# KENWOOD

ASB-1049

## Service Bulletin

**Subject:** TS-850S "Click Noise" with Notch On

X48-3080-00 Foil Side View

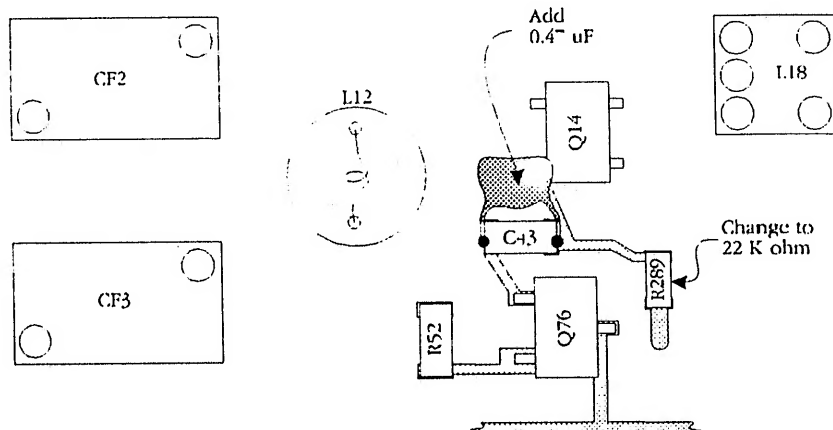
When a strong signal of S-9 or greater is received at the antenna terminal with the NOTCH circuit ON a "clicking" noise might be noticed. This is caused by excessive response in the AGC loop circuit.

The changes detailed below will add additional delay to the AGC circuit and reduce or eliminate this tendency.

Qty	Description	Old Part No.	New Part No.	Circuit Description
1	22 k Ohm chip resistor	RK73FB2A103J	RK73FB2A223J	R289
1	0.47 uF capacitor	NA	CQ92M1H474K	NA
